ADDENDUM NO. 4

PROJECT NO. DGS A-0199-0090 PHASE 001

PROJECT TITLE - White Oak Pond - Design, Construct & Rehab Dam

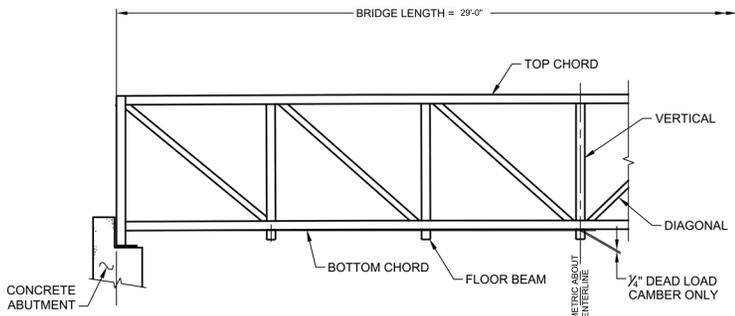
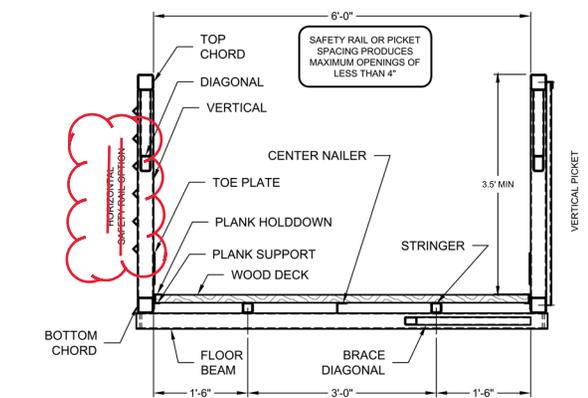
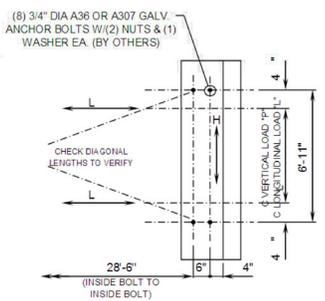
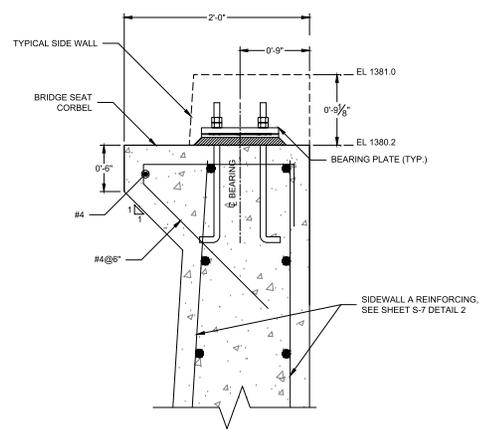
Item 1 - Drawings S-14 Detail 3 Bridge Section shall be revised to remove the horizontal safety rail option text, vertical picket shall be used. See attached Revised Drawing S-14.
